Addendum No. 02

Issued: 9/13/2024

Project Name: Jordan Learning Center
Project No.: 2024528.00
Bid Package: 1

SHEET NUMBER:
LP501

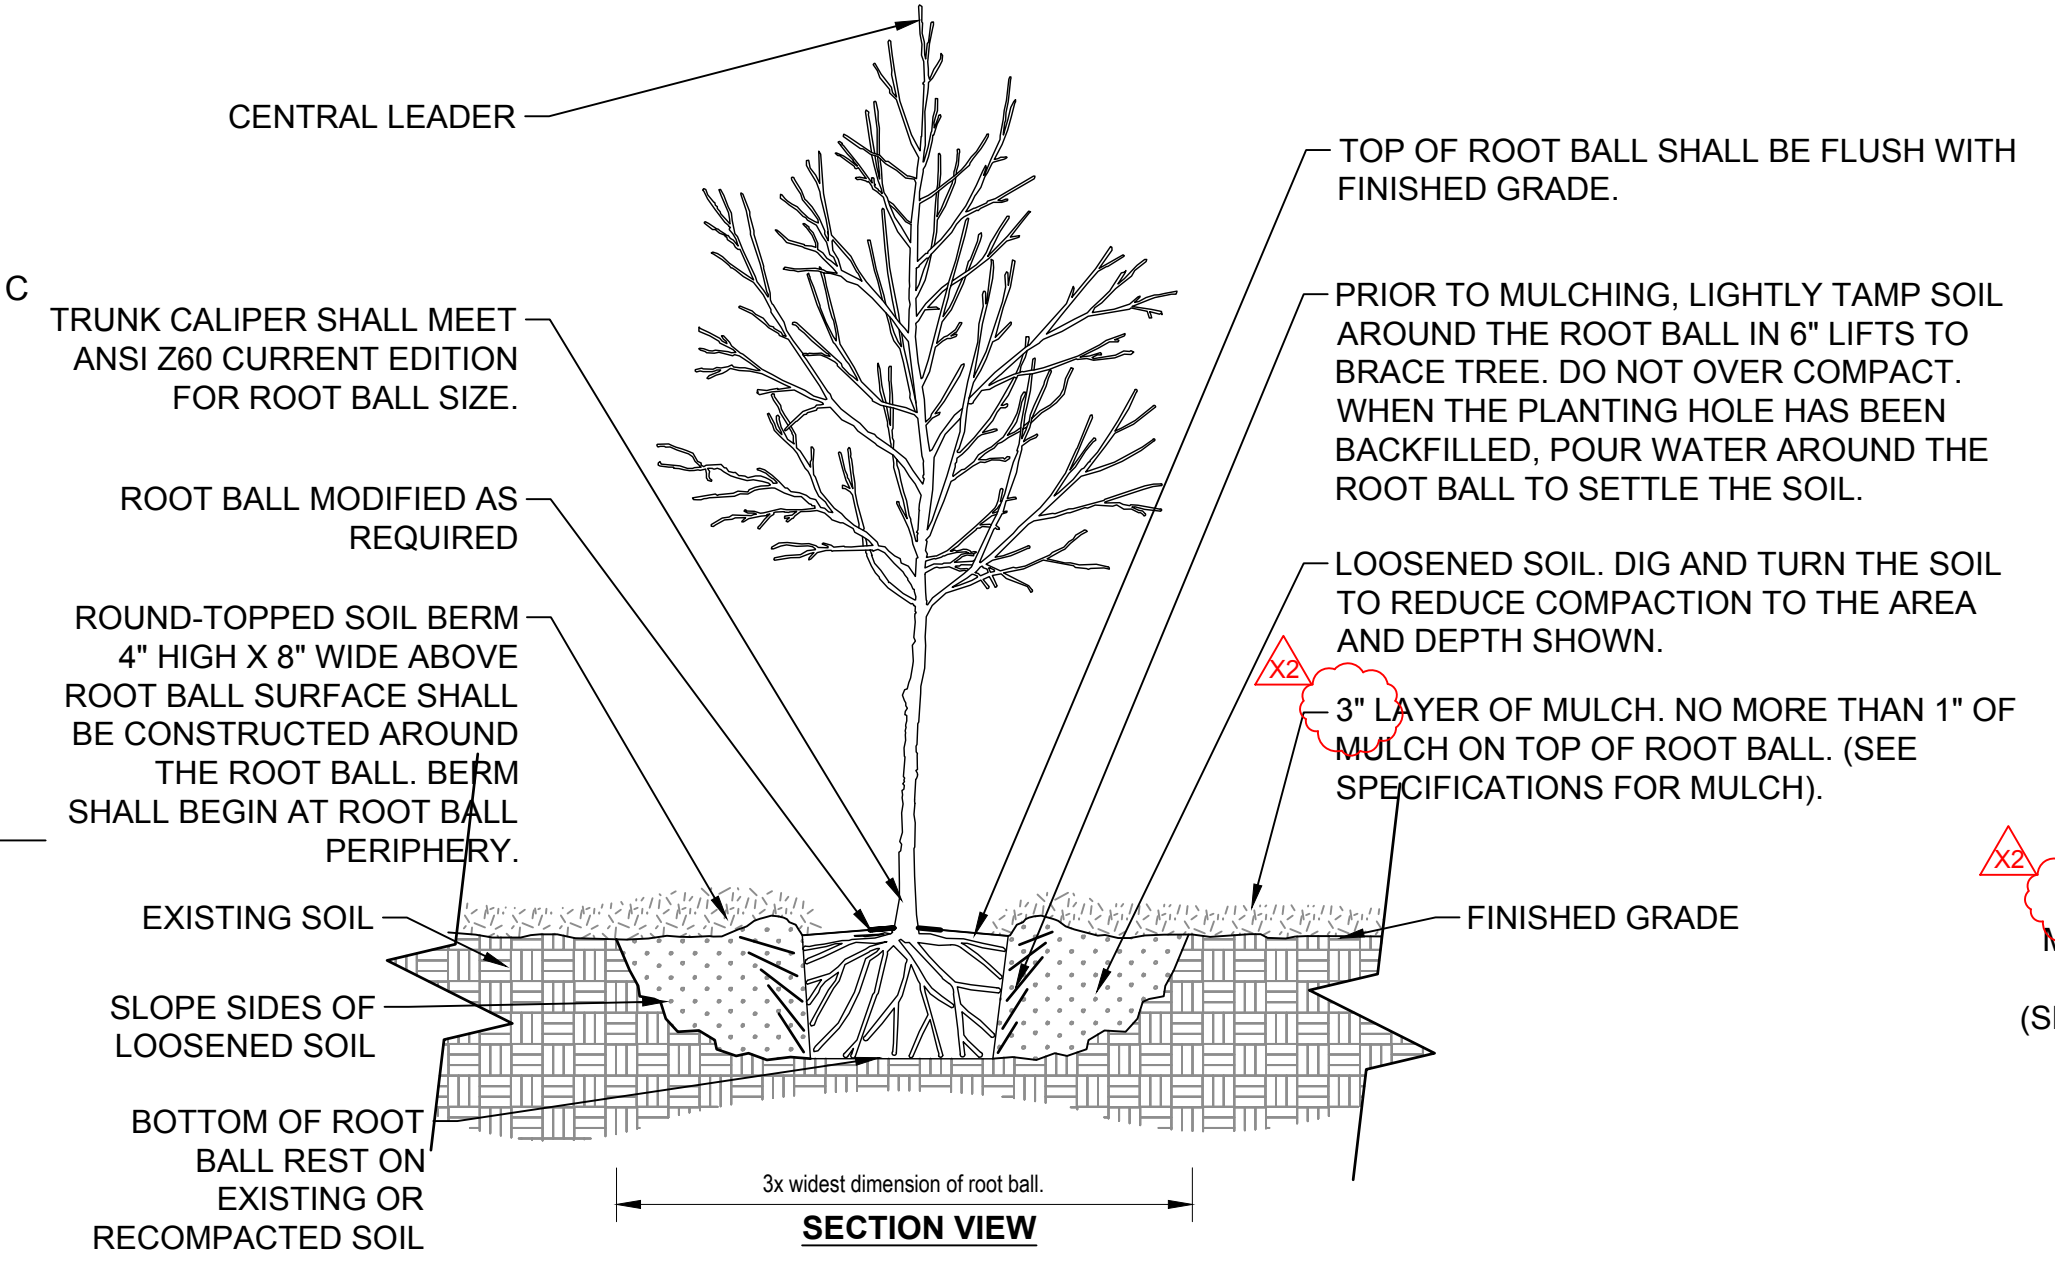
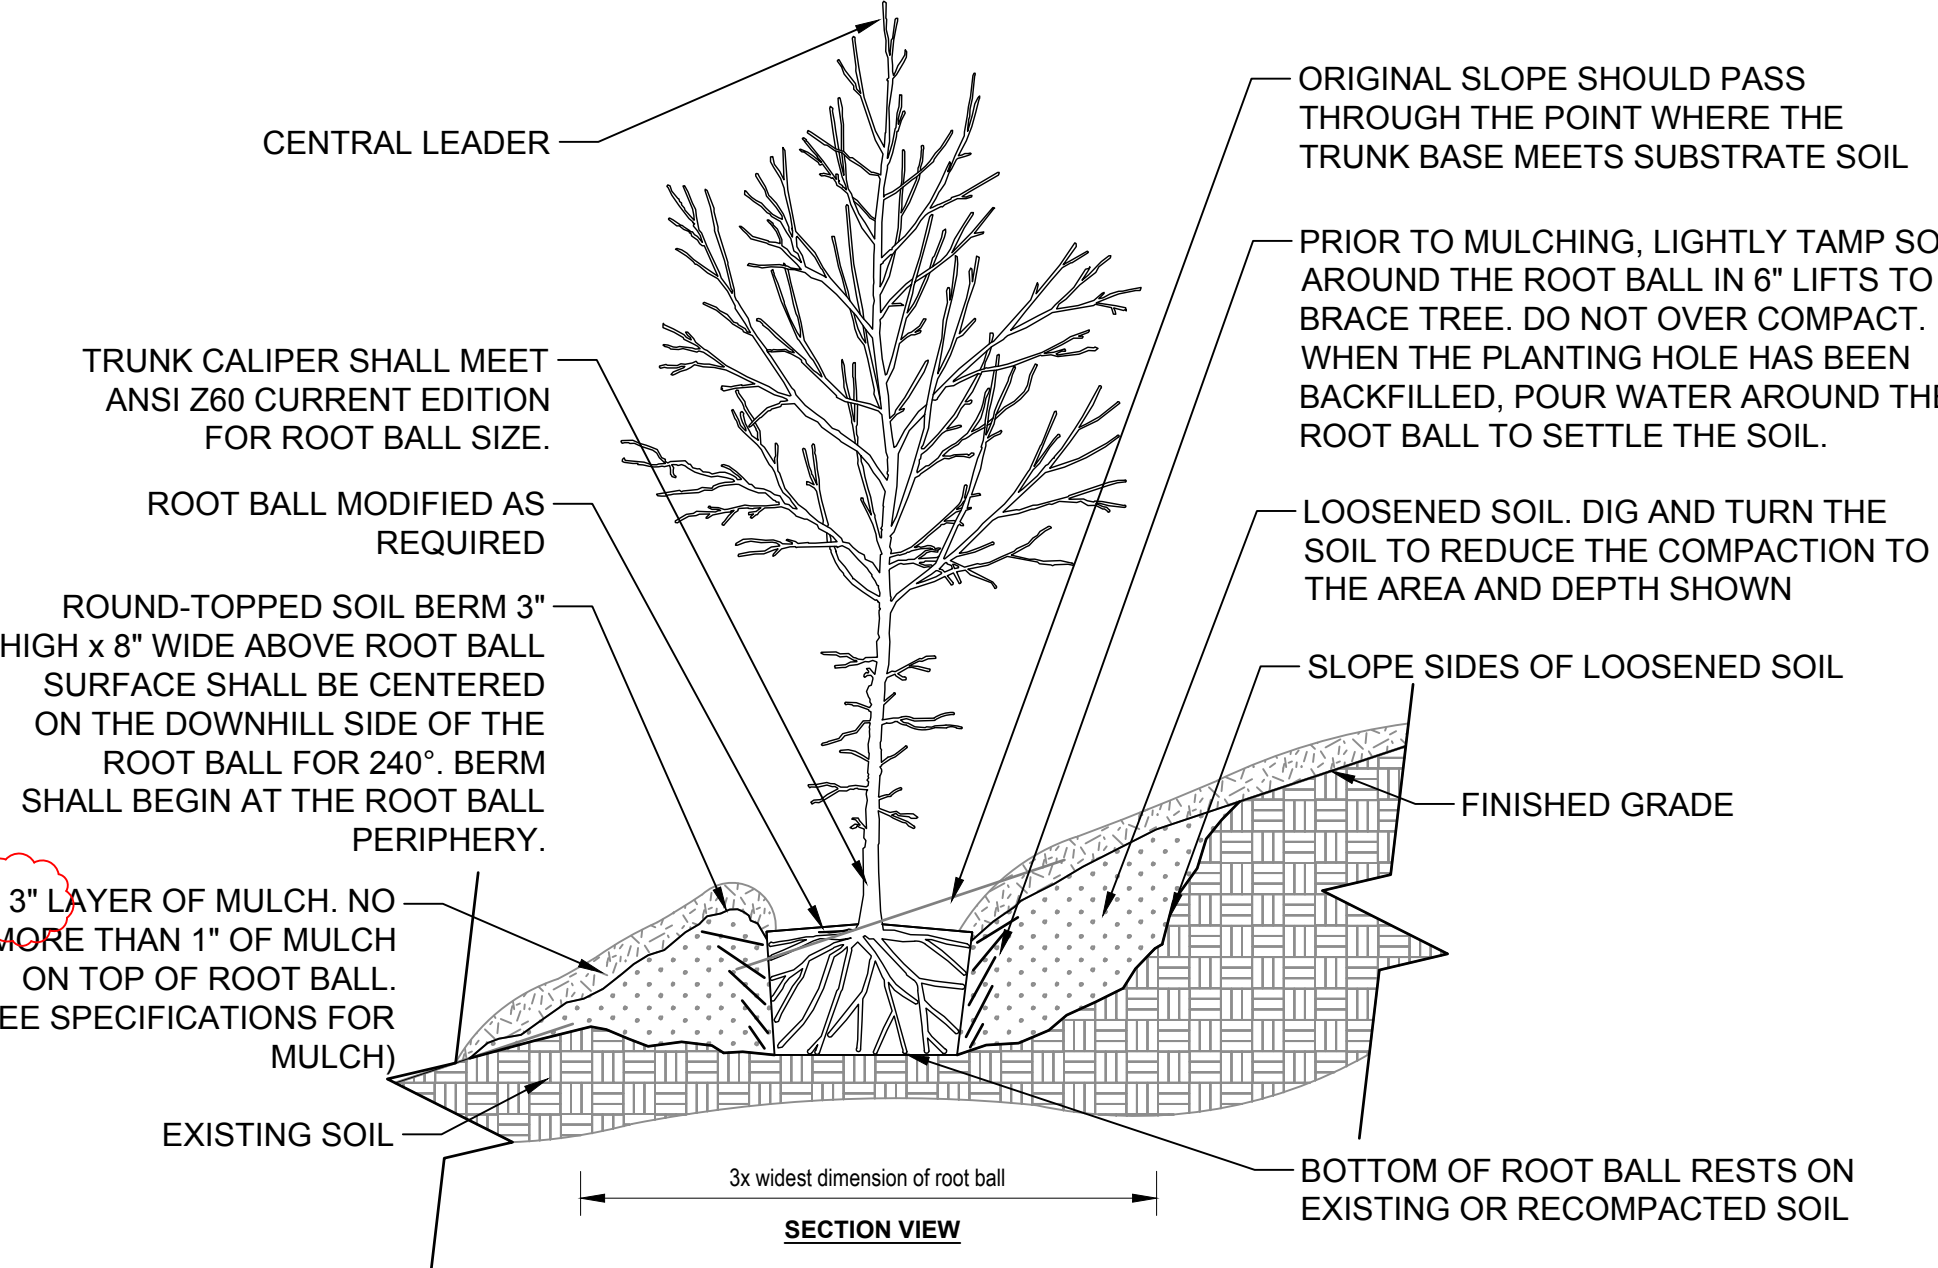
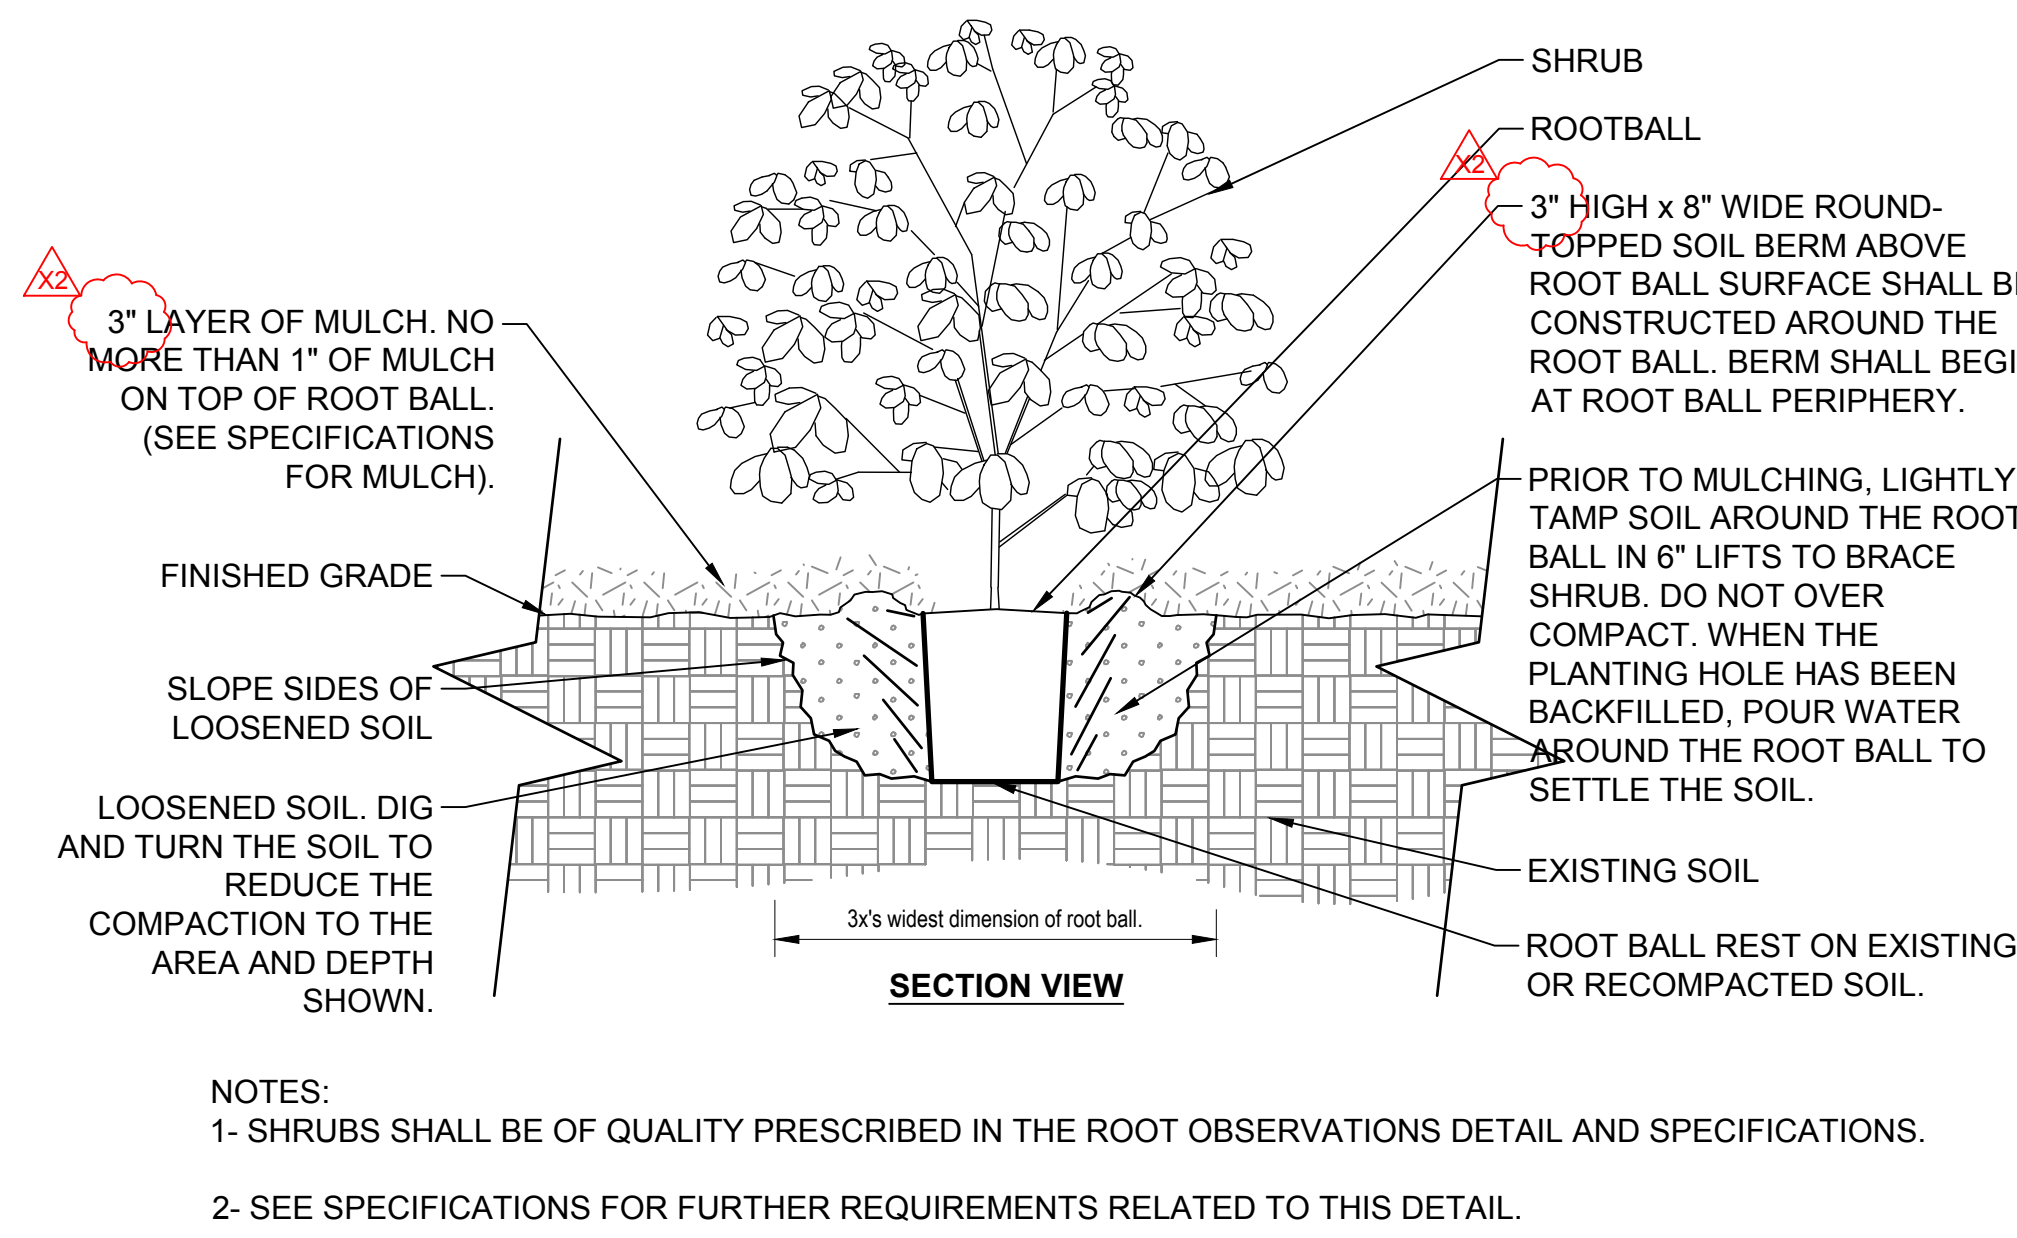
- Removed planting schedule from sheet.
- Revised details D1, D3, E2, E3, to have 3" mulch depth requirements.
- Refined planting notes.
